IN THE DRAWINGS:

Applicant has filed this Reply & Amendment responsive to the Office action dated January 22, 2007.

Cooling System  
Inventor: Brian A. Hamman  
Docket No.: QNX002

Fig. 7A

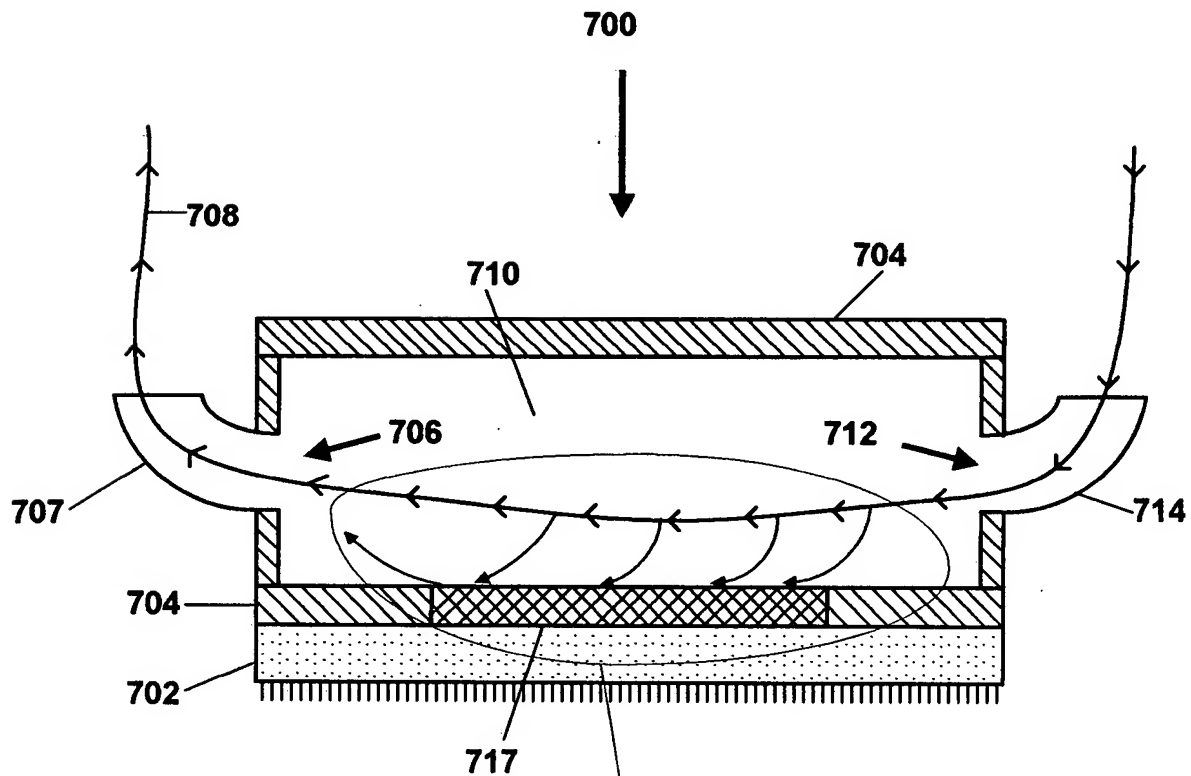
2. The Examiner has required a Drawing change depicting "... coolant direct contact with the surfaces of the heat-generating components ..."

Figure 7A (Currently amended) is replaced with the Figure 7A Replacement Sheet attached to this Reply & Amendment. An Annotated version of the original Figure 7A is also included depicting the changes to this Figure 7A. The change consists of adding additional coolant flow arrows which show that coolant comes in direct contact with the surface (717) of the heat generating component as disclosed in the specification starting at paragraph [0122]. The name and telephone number of the attorney has also been updated.

3. Applicant believes that Drawings adequately depict direct contact of the coolant with surfaces of the heat-generating components. Nevertheless, Applicant has amended Figure 7A to show additional coolant flow arrows making direct contact with a surface 717 of the packaging of the heat-generating component 702. This does not represent new matter as this is described in detail in the Specification starting at paragraph [0122].

Additional coolant flow arrows added
